Permit Application Review Report
Date: 6/3/2026

Project Name: NR Properties - Blaine Industrial Building

Project PAN: P-26-020

Project Purpose: new commercial building with parking areas and stormwater treatment

Figure 3: Soils and Erosion Control

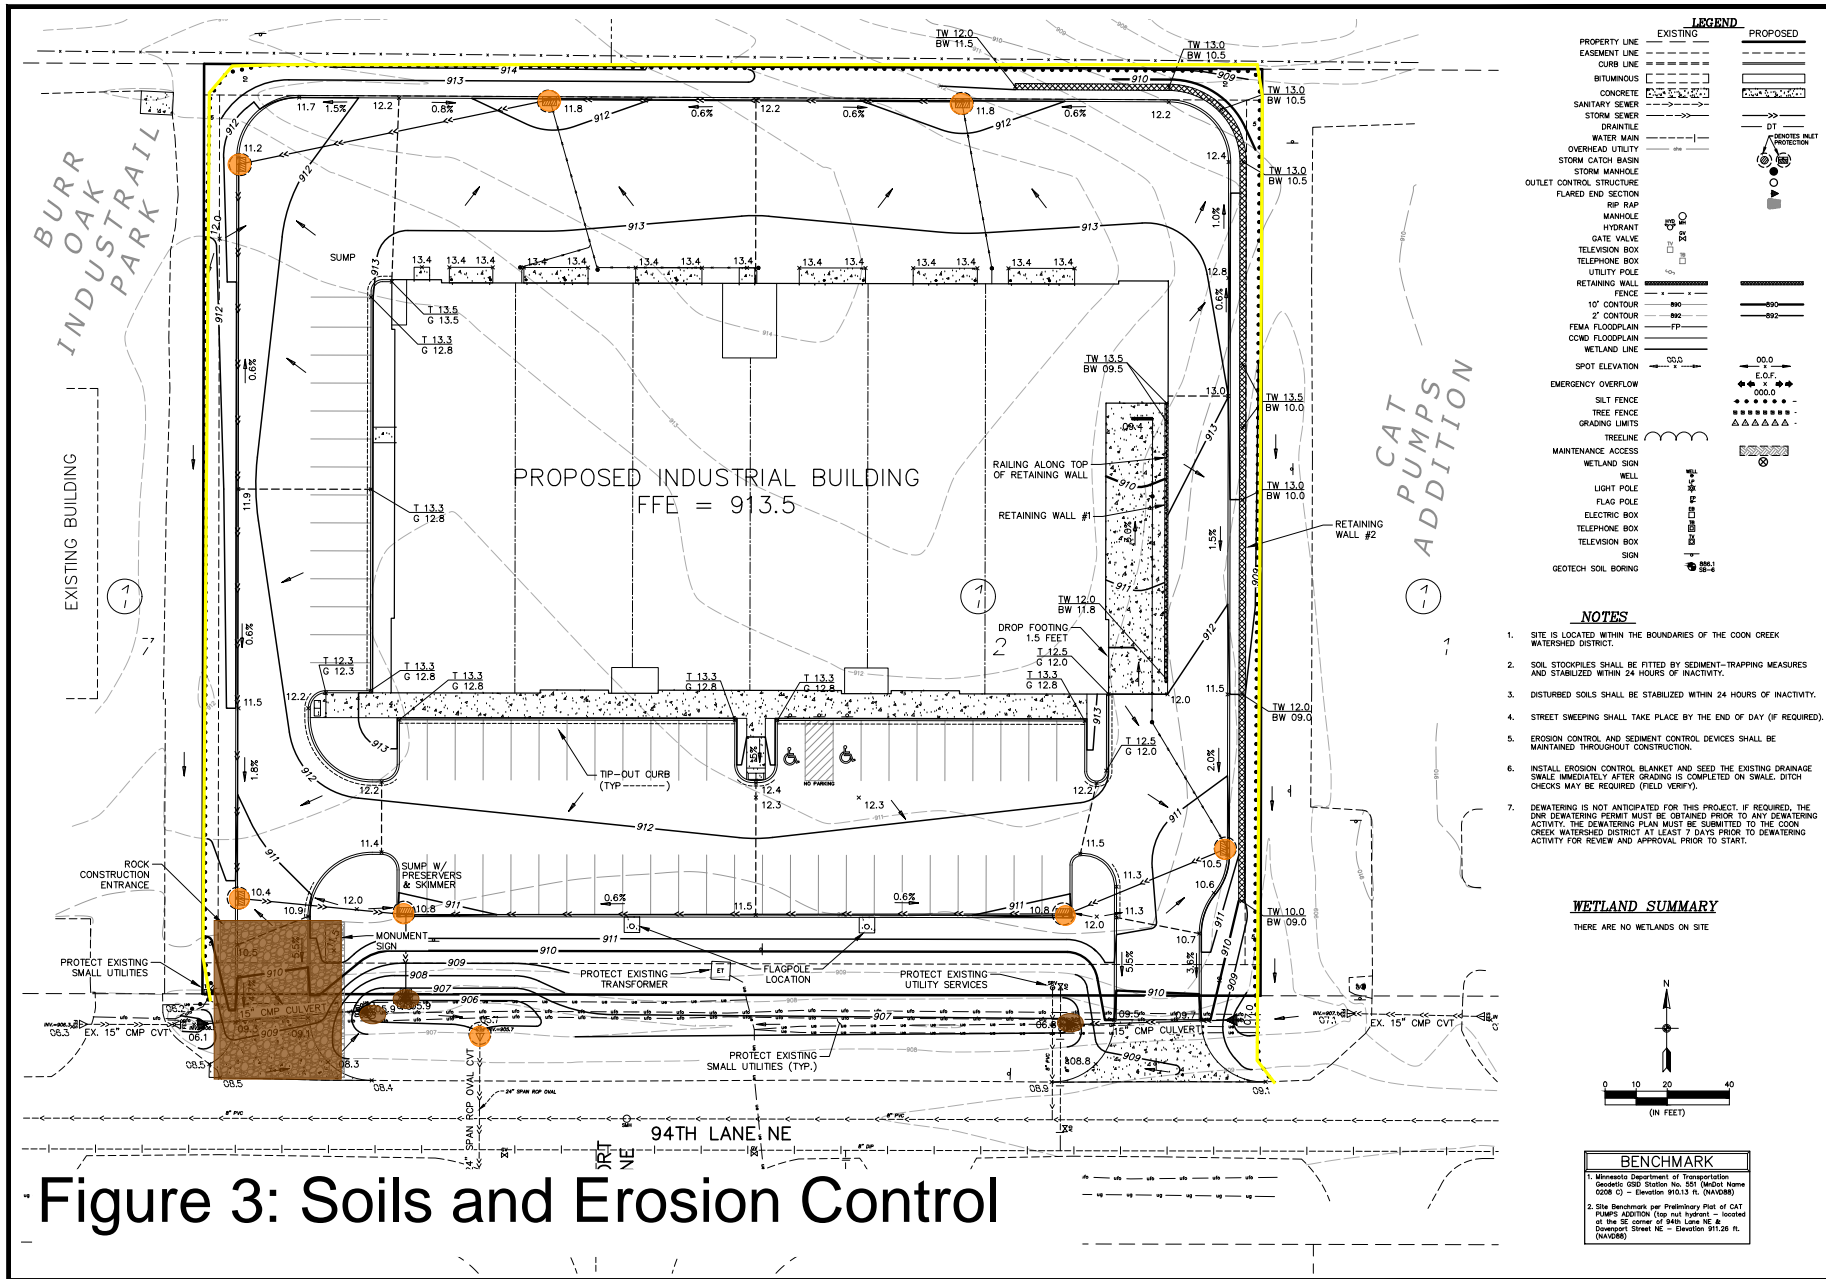
The proposed project drains to Ditch 41. The soils affected by the project include Zimmerman and have a soil erodibility factor of 0.15 or greater. Disturbed areas are proposed to be stabilized within 7 days, as required. The proposed erosion and sediment control plan includes perimeter control, stabilized construction entrance, street sweeping and inlet protection. The erosion control plan meets District Requirements. The site does require an NPDES permit. See attached Figure 3: Soils and Erosion Control.
